## **261M COIL, MAGNET ASSEMBLY**

## TP171748 AND TP199997 TORSION SPRINGS

Figure 1

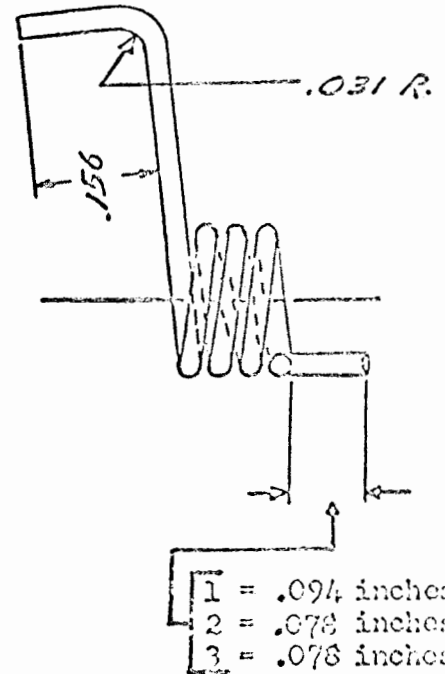
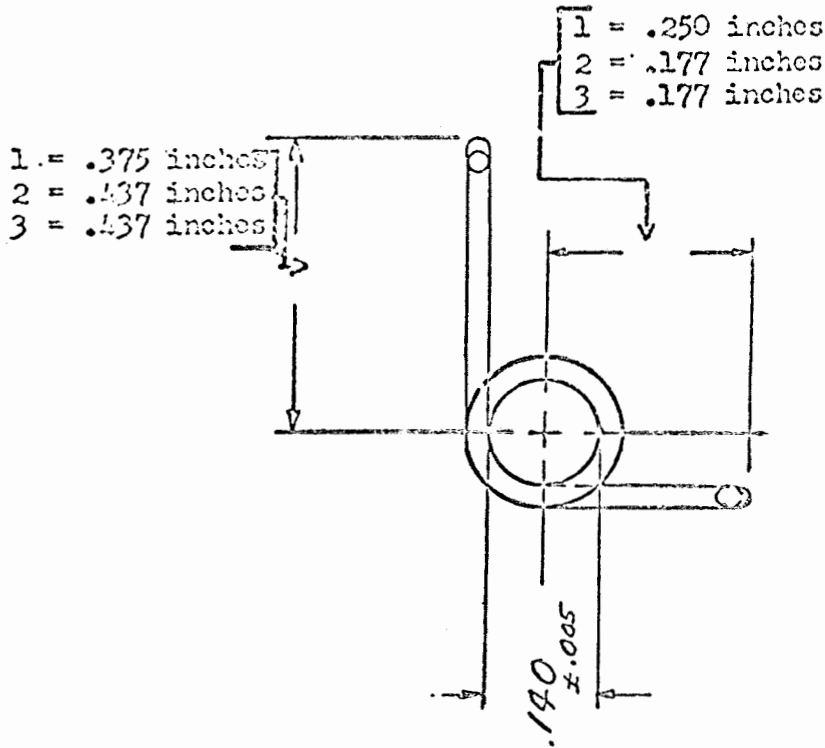
*CHANGE:* The TP171748 tape lid torsion spring has been replaced by the TP199997 tape lid torsion spring for use with the TP193664 tape lid on tape readers having 2-piece top plates. The new spring is identical to the present TP171748 spring and the change to the new part number is only for identification purposes. Old style springs can be stocked as a TP199997 spring.

The design of the TP171748 tape lid torsion spring has been changed and is to be used only with TP171734 tape lids on early model tape reader units having 3-piece top plates. This spring will be furnished only for maintenance orders.

The specific dimensions identifying the types of tape lid torsion springs are shown in Fig. 1. Refer to Teletype Bulletin 1176B, issue January 1963, pages 1-5 and 1-7.

*INTERCHANGEABILITY:* Old style TP171748 springs and new style TP199997 springs are interchangeable. New style TP171748 springs and old style TP171748 springs are not interchangeable.

*W.E.CO. STOCK OF OLD STYLE PARTS:* Old style TP171748 springs may be stocked and furnished as the TP199997 spring. New style TP171748 springs shall be furnished only for use on early model tape readers having 3-piece top plates.

*APPLICATION AT W.E.CO. DIST. HOUSE REPAIR SHOPS:* All late model tape reader units having 2-piece top plates shall be equipped with either old style TP171748 springs or the new TP199997 springs.

All early model tape reader units having 3-piece top plates shall be equipped with new style TP171748 springs.
